UTUMC
Seattle, WA

University Temple United Methodist Church
Recommendation Meeting 02
March 22, 2021
SDCI: #3034224-LU

RESPONSE TO RECOMMENDATION MEETING 01

Sketch of Proposed Tower Concept

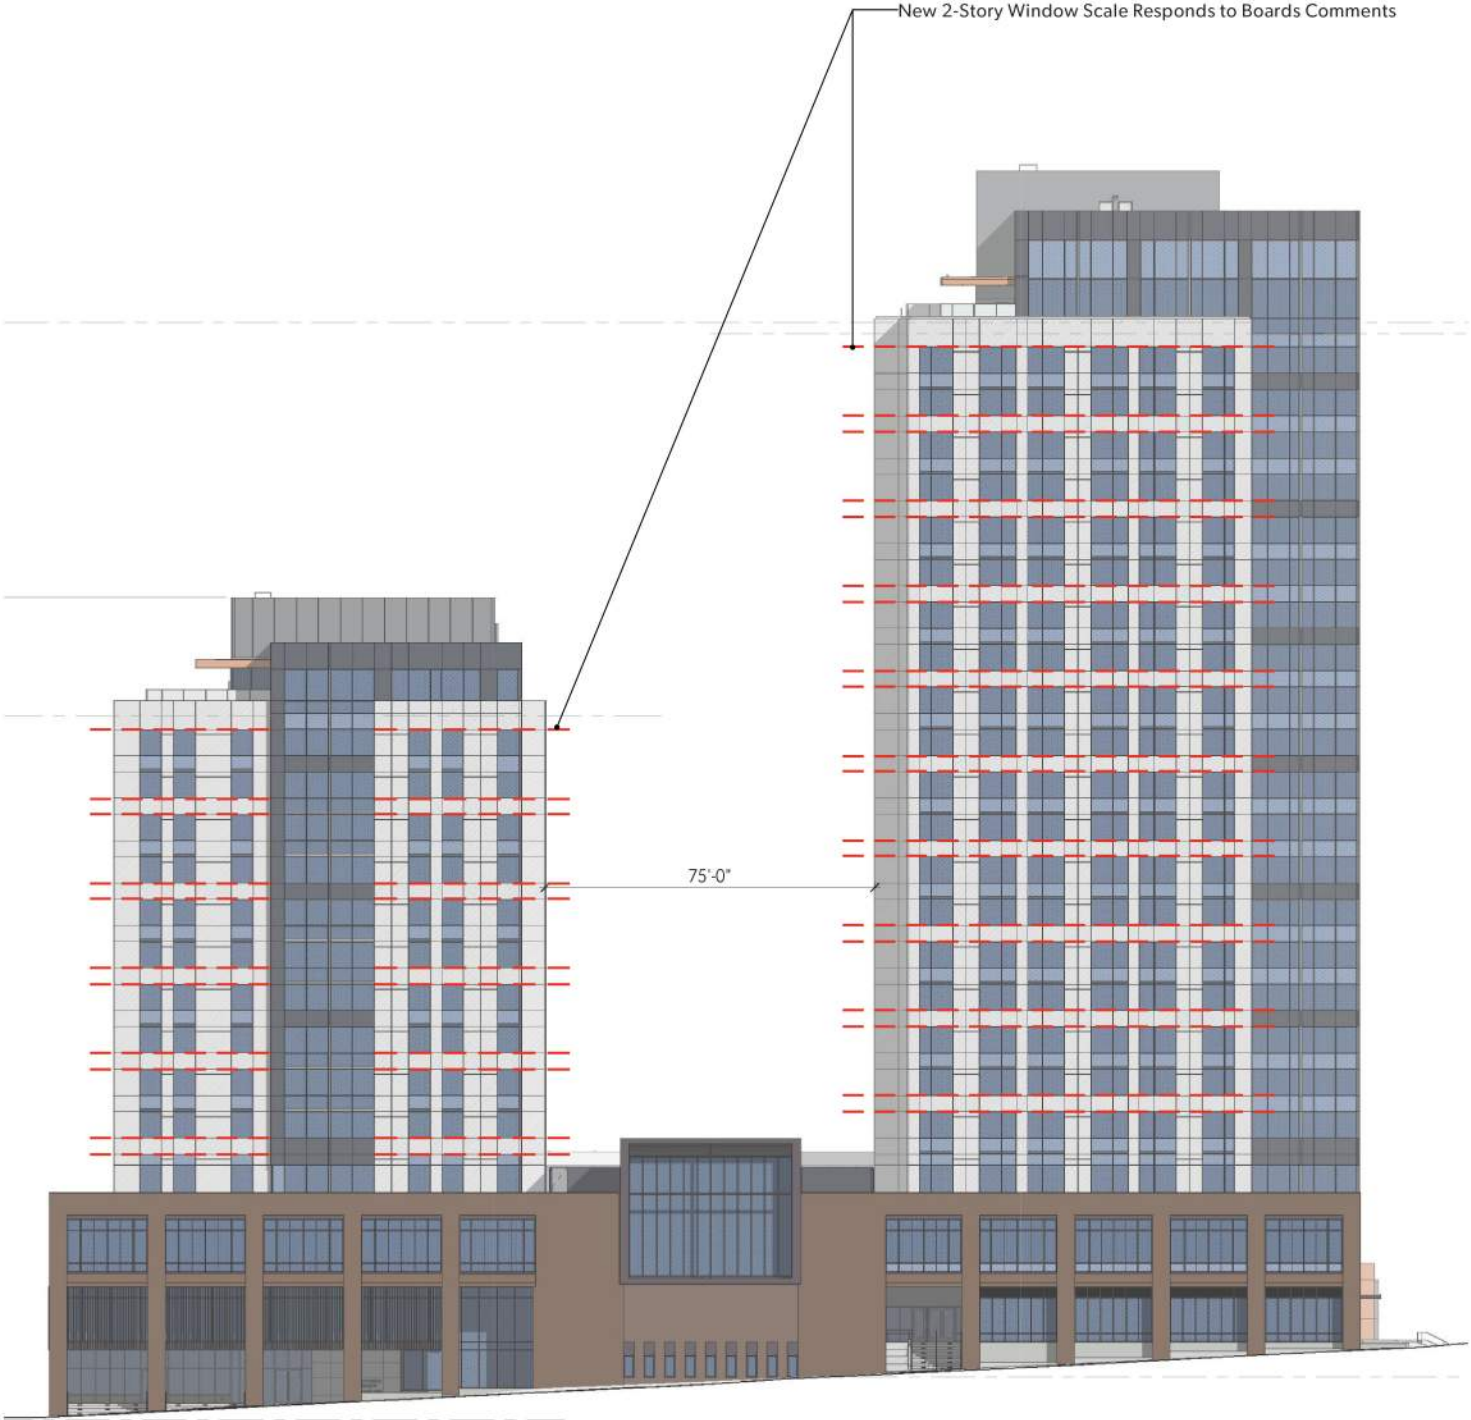
- Response: Noted
 - g. The Board appreciated the design team’s attempt to respond to the different sides, exposures, and corners of the building but observed that many of the elements of the tower were too disjointed. The Board urged the team to revisit the sketch imagery seen on page 40 of the packet which does a better job depicting the building’s overall design intent. (CS2-B-2, CS2-B-3, PL3-A, PL3-I)

- Response: The scale, module, proportion and greater opacity seen in the page 40 “north tower study” has now been incorporated in the tower body of both the north and south towers.

Proposed 15th Ave NE Colonnade Plan

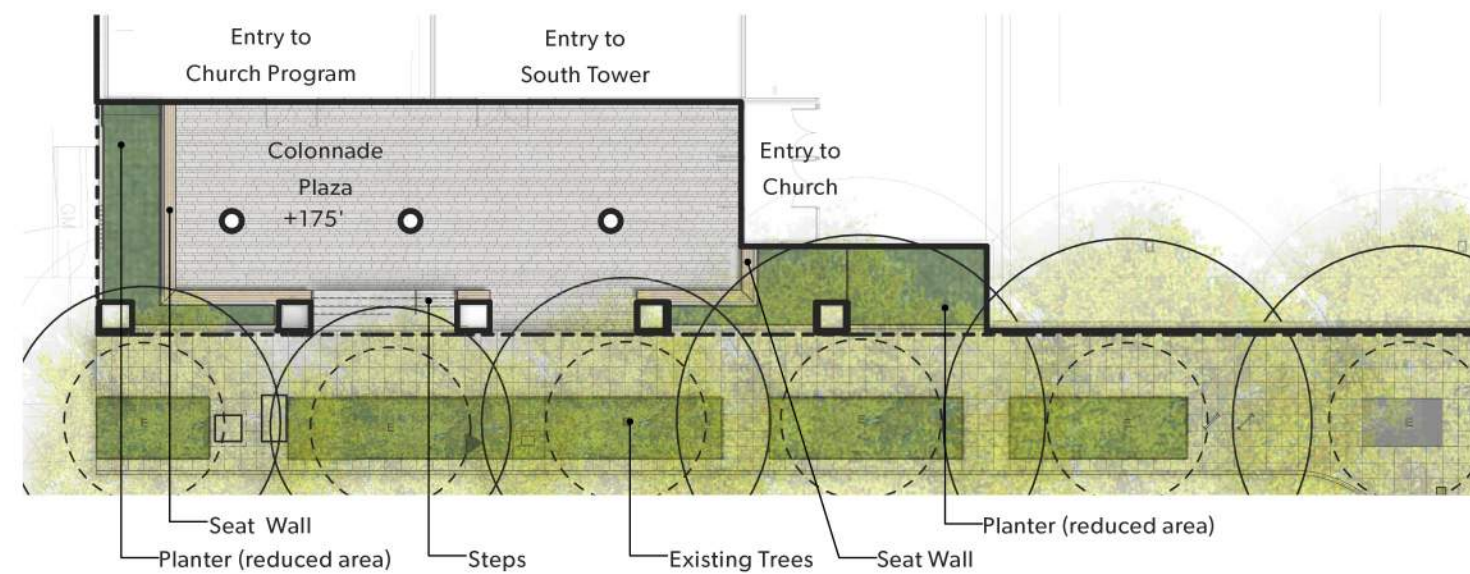
- b. During EDG, the Board verbalized their support of the public open space and open connection to the sidewalk at the corner of 15th Ave NE and NE 43rd St, designed at grade and as an extension of the sidewalk. The Board was troubled with the latest iteration shown at the Recommendation meeting, which depicts the area as raised up with a ramp, stairs, and a planter. As such the Board directed the design team to return the space to the grade of the sidewalk and reconfigure the planter so that the space reads as a continuation of the public realm. (PL3-I-c, DC3-C-2, DC2-VI-k)

- d. The Board directed the design team to revisit the open space along 43rd St and explore ways to make it more open and accessible by the public, directly from the sidewalk, without the use of stairs or having planters in the way. (PL3-A, PL3-I)

Response: The colonnade along 15th and has been modified to improve both visual and pedestrian access from the adjacent public sidewalks. Planting was pulled back and stairs were expanded, to make the east edge of the space very porous and more inviting. Benches have been positioned into the space to both view the street activity and to be part of the space itself.

Proposed 15th Ave NE Colonnade Plan

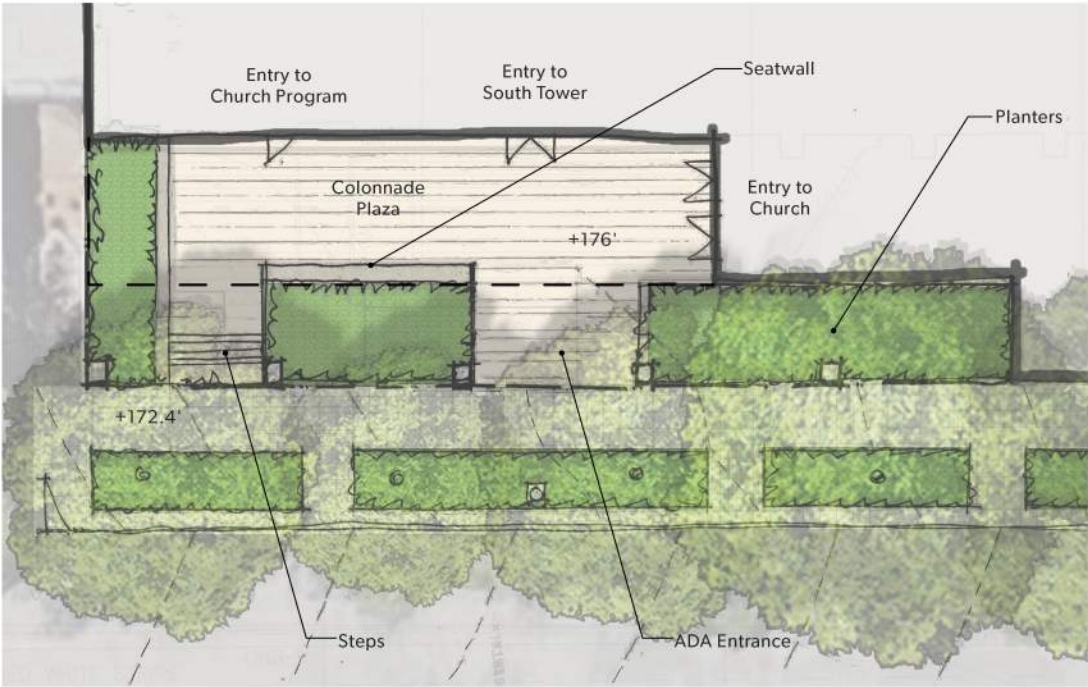
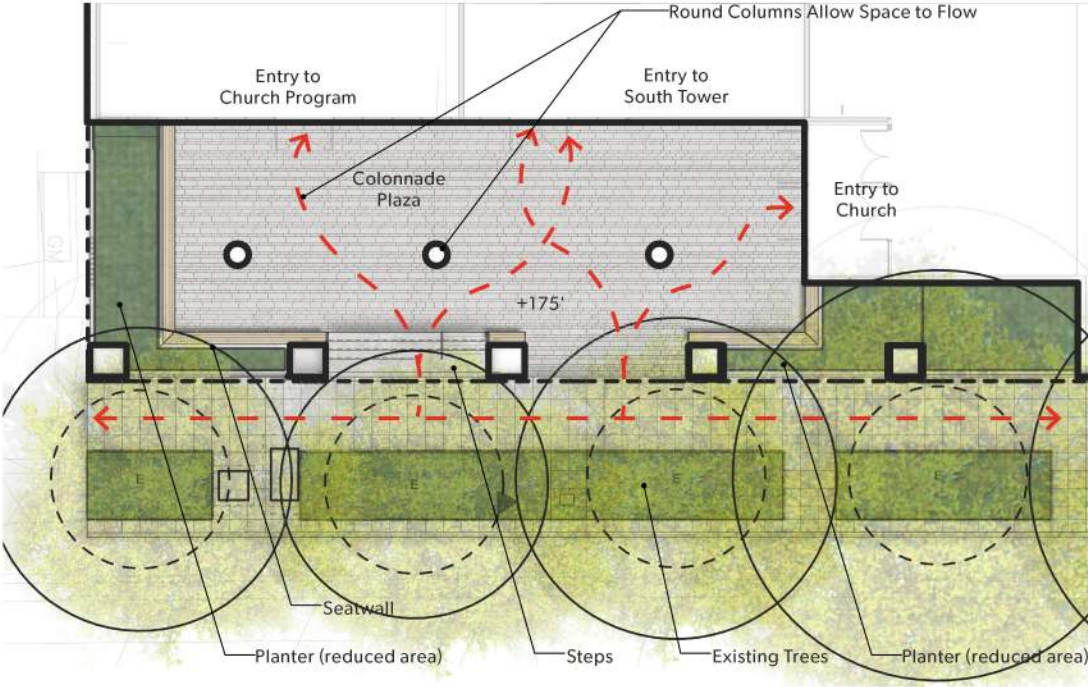
Response: Noted
- d. The Board discussed at length various concerns they had with the colonnade, its perceived height and scale of the open/gathering space and gave guidance that the space needs to be more inviting with a higher degree of comfort so that it does not feel so overwhelming. (PL3-I-C, DC3-A, DC3-B)

Response
In response to the Board's feedback at EDG, the applicant has significantly reduced the planted area to provide a better connection from the colonnade to the street. Access to colonnade is front and center in the central column bay to provide stronger visual access from the street and logical wayfinding. To make the space less imposing, the brick pilasters are reduced in depth and the inboard tower columns are round to allow space to flow around them. Additionally, the Church entry vestibule has been pushed north opening the space more as well. All these design moves result in a more public and inviting colonnade.

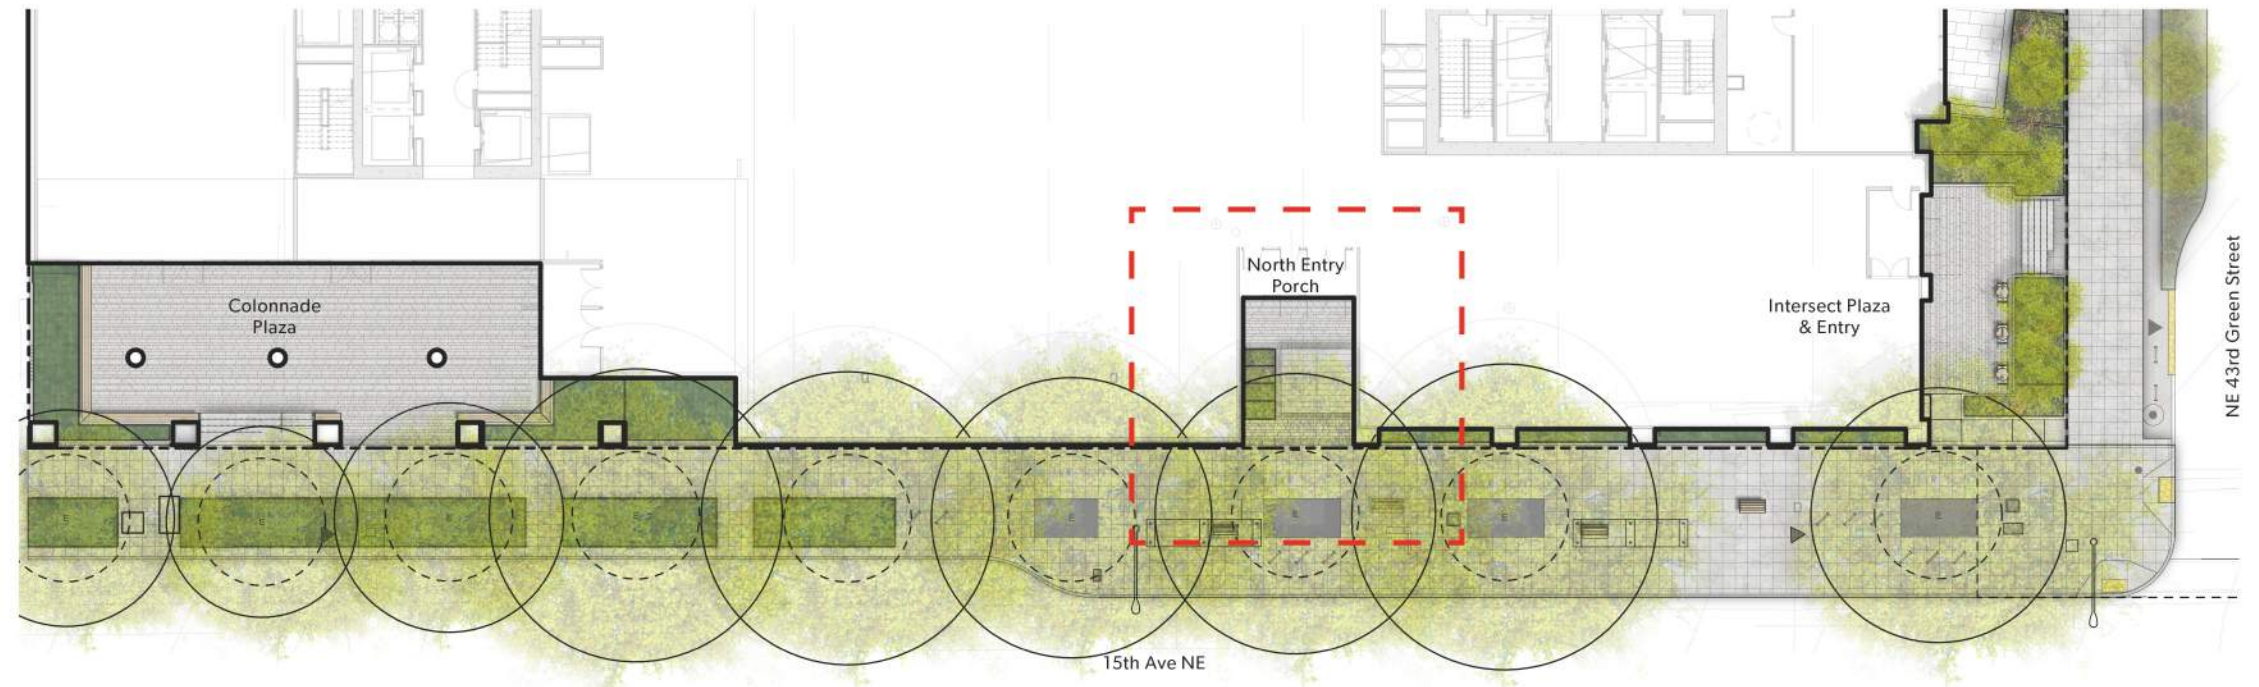
- e. The Board requested additional information on how the grades work in relationship to the street and to the back wall of the colonnade. (CS2-B-1)

The main at-grade entry of the colonnade is at grade (at +175.00'), with the sidewalk sloping up towards the north, and down towards the south. Planters respond to the grade, and planter height is minimized from the street side. South of the stairs, the planter soil slopes down towards the east to minimize planter height. North of the main at-grade entry, the planters gently terrace up to be above the sidewalk surface, but are less than 18 inches tall.
